# SERVICE BULLETIN SPSB009

SUBJECT: SUPPLIER/VENDOR RECALL OF PS70104 HOUSINGS (METAL FLEX HOISING INC)

STATUS: MANDATORY INSPECTION AND REPLACEMENT OF RECALLED HOUSINGS

**ALL JA101-XX HARNESS CONTAINER ASSEMBLIES (JAVELIN ODYSSEY) WITH METAL FLEX HOISING BATCH # 33234 A AND 33227, .375ID PS70104 HOUSINGS. SEE SERIAL NUMBER LIST BELOW.**

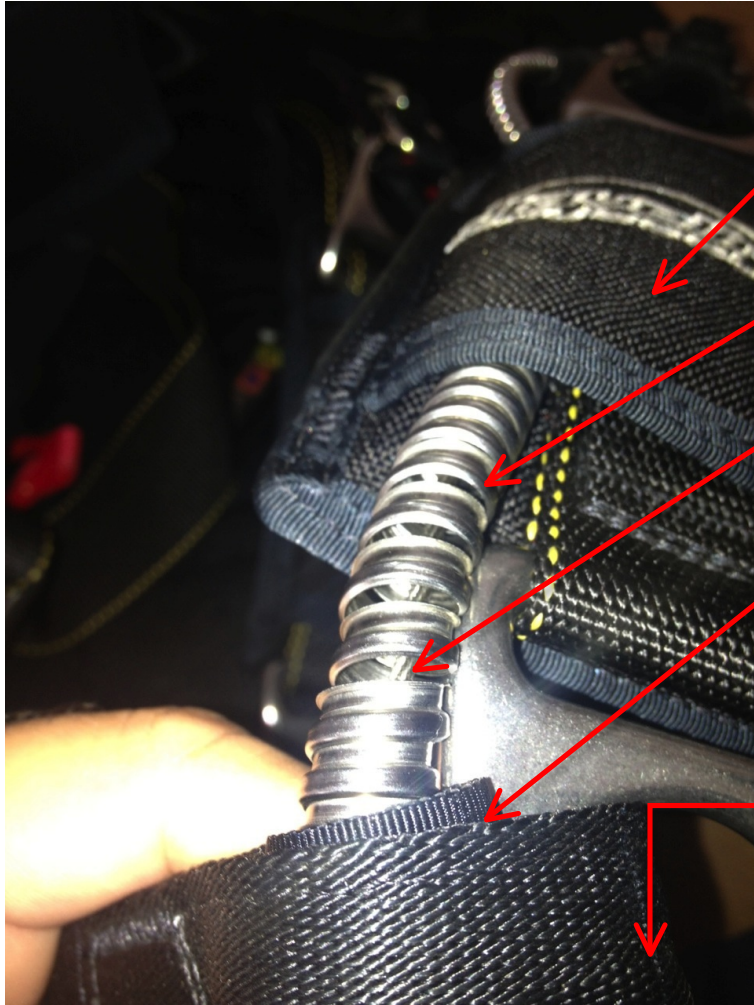
Metal Flex Hosing (supplier of flexible metal housings) has recalled 195 total PS70104 .375" ID SS housings due to the ability of the coil to separate. 155 of these housings were received by Sun Path Products, Inc., 124 of which were installed in harness container assemblies, 27 pulled from inventory prior to use and 4 damaged/discarded. (Note: this is not a failure mode. Separating of the coil does not impede normal operation or function of the system)

If the serial number is listed in the above table, inspect the available exposed reserve ripcord housing. Locate the lower end of the housing, which is clamped to the Main Lift Web, just above the reserve ripcord pocket. Inspect the exposed length of housing from the clamp upwards; ensure that the coil has not separated/unraveled. Be sure to inspect the section that is routed through the chest strap.

A. **HOUSING FOUND TO BE INTACT (GOOD):** The rig may continue to be jumped with periodic monitoring until the next repack cycle or earlier elective replacement. However this housing must be replaced at the next repack cycle. See <http://www.sunpath.com/support/HousingReplacement.pdf> for instructions for your rigger to complete the replacement of the housing.

B. HOUSING FOUND TO BE SEPERATED/UNRAVELLED (BAD): The housing must be replaced before the next jump by a certificated senior or master parachute rigger (or foreign equal) or the manufacturer. See <http://www.sunpath.com/support/HousingReplacement.pdf> for instructions for your rigger to complete the replacement of the housing or instructions to send your system back to the manufacturer.
